NORTHWEST ATLANTA LIBRARY

ADDENDUM #2

March 17, 2014

SDA-001

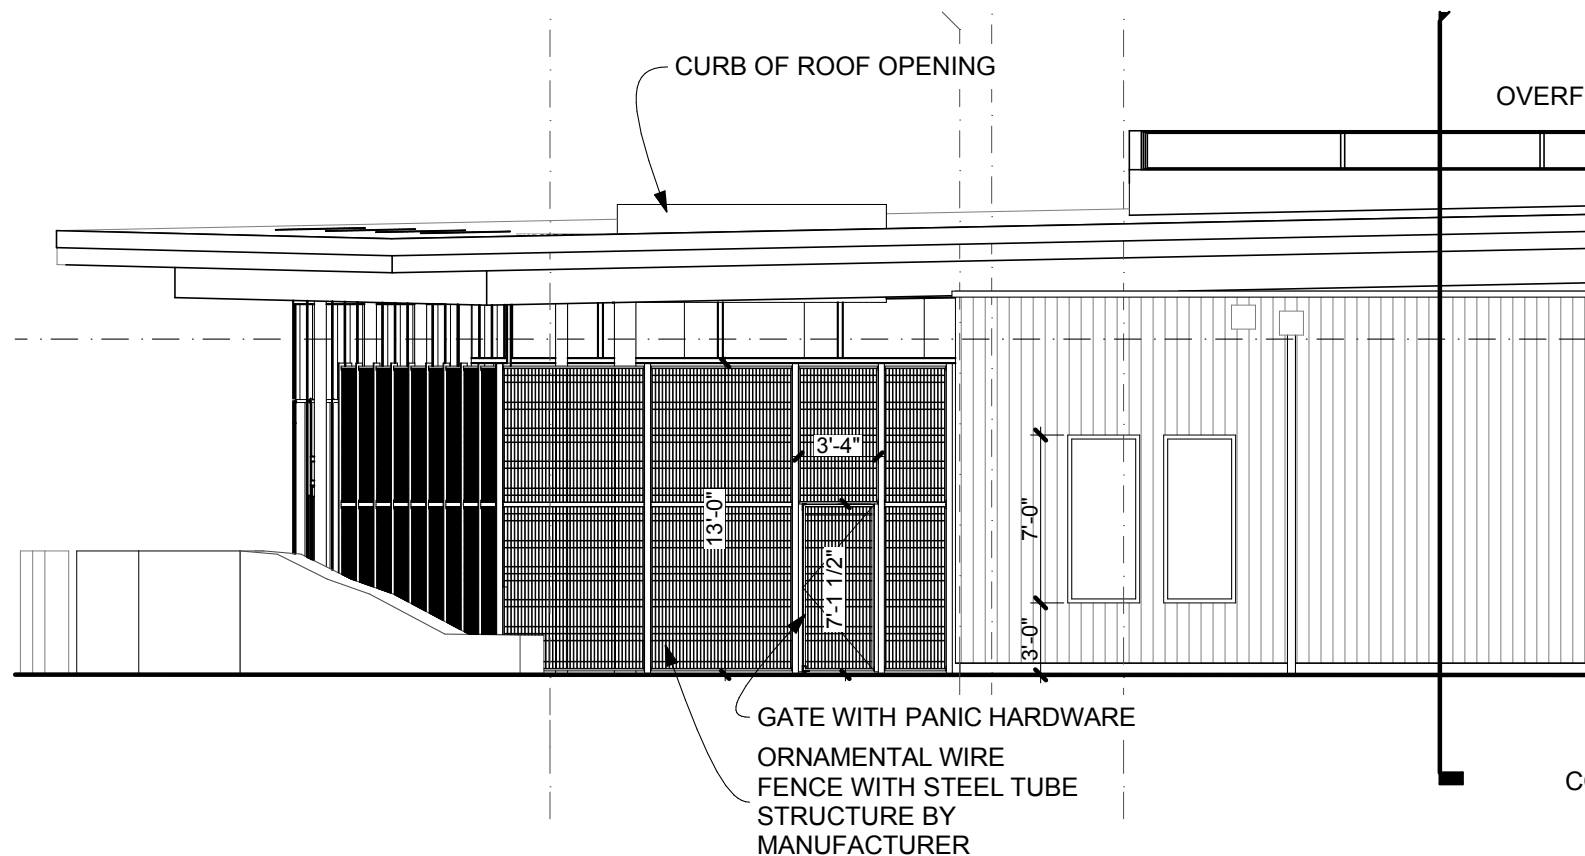
4. Please confirm the required thickness of the exterior gypsum sheathing. The drawings call out for the sheathing to be 1" Fiberglass Faced Gypsum Sheathing. This material is made in either 1/2" or 5/8". Please confirm which is required.

Answer #4: 5/8" fiberglass faced gypsum sheathing and 1" rigid insulation. See attached SDA-001 for typical detail.

SDA-002

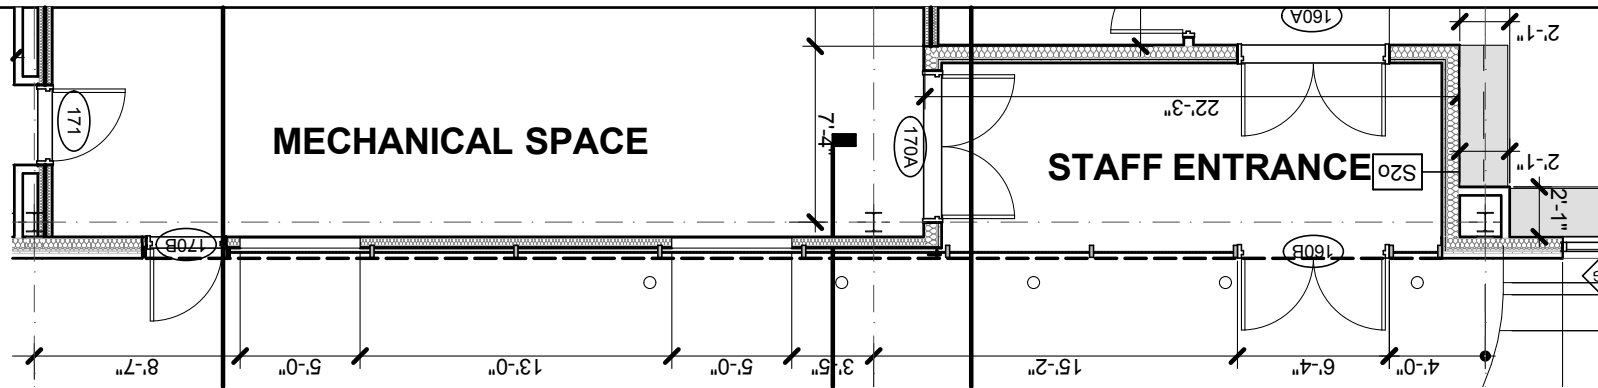
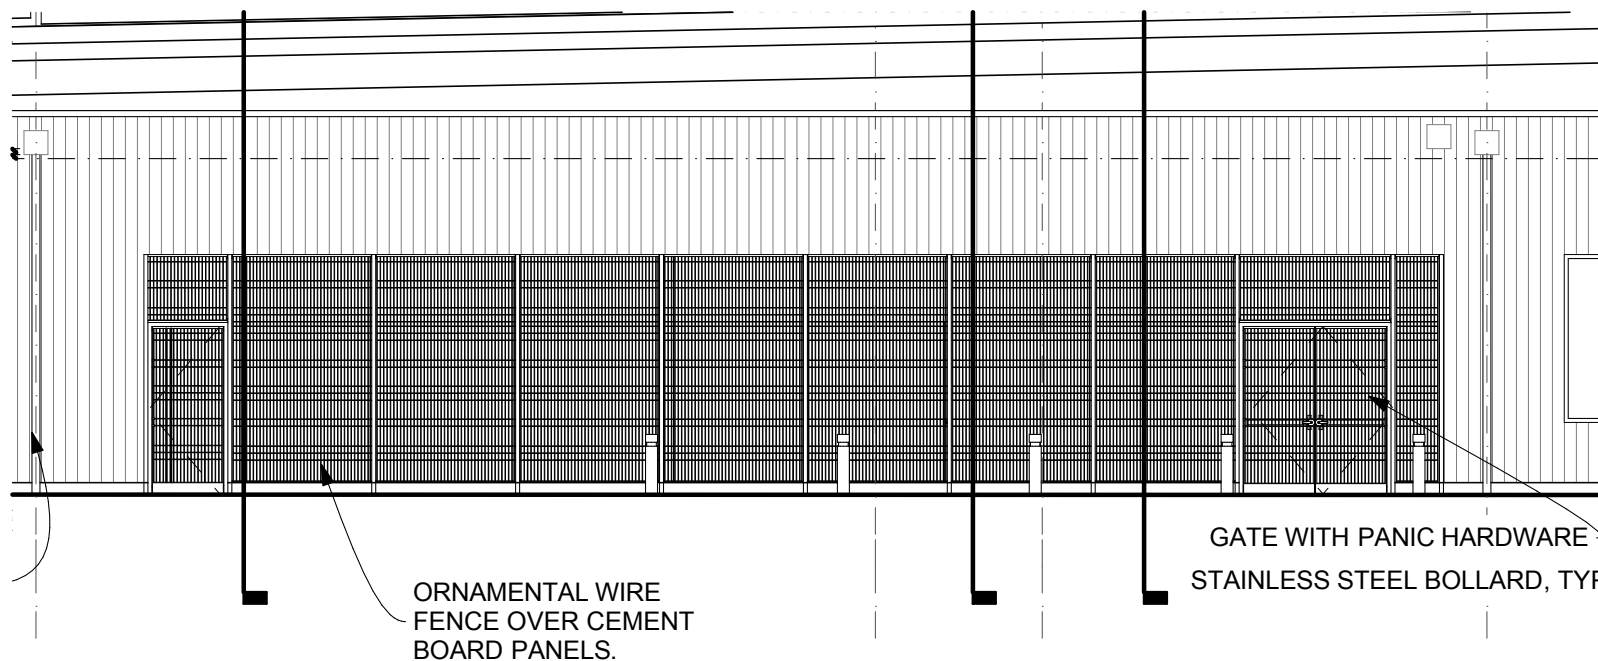
6. Please provide further information for the steel tube structure that is required for the perforated screens at the Children's Area. Also, will any steel tube structure be required for the perforated metal panel system at the North Elevation?

Answer #6: Steel for the screen at the children's play area will be provided by the fencing manufacturer. See attached system as basis for design. See attached SDA-002 & SDA-003 for clarification.

SDA-004

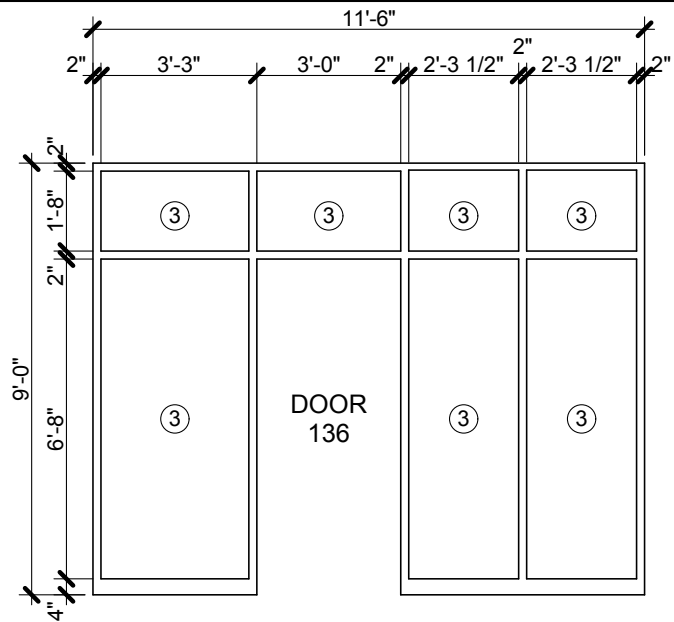
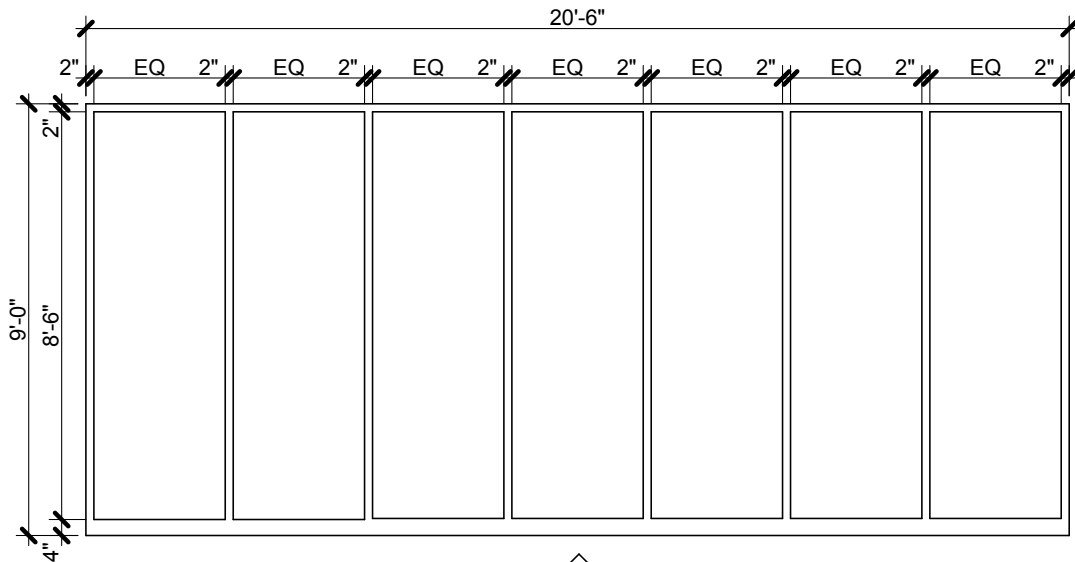
8. Storefront Openings 6 & 7 are shown on Sheet A-601 as 10'-8" openings but scale on the interior elevations to 9'-0". Please confirm which is the correct height.

9. The interior Storefront Partition at the Teen Pod is not shown on the Storefront Schedule but appears on the plans. Please confirm the dimensions of this Storefront.

Answer #8: See attached SDA-004 for dimensions.

Answer #9: See attached SDA-004 for storefront dimensions.
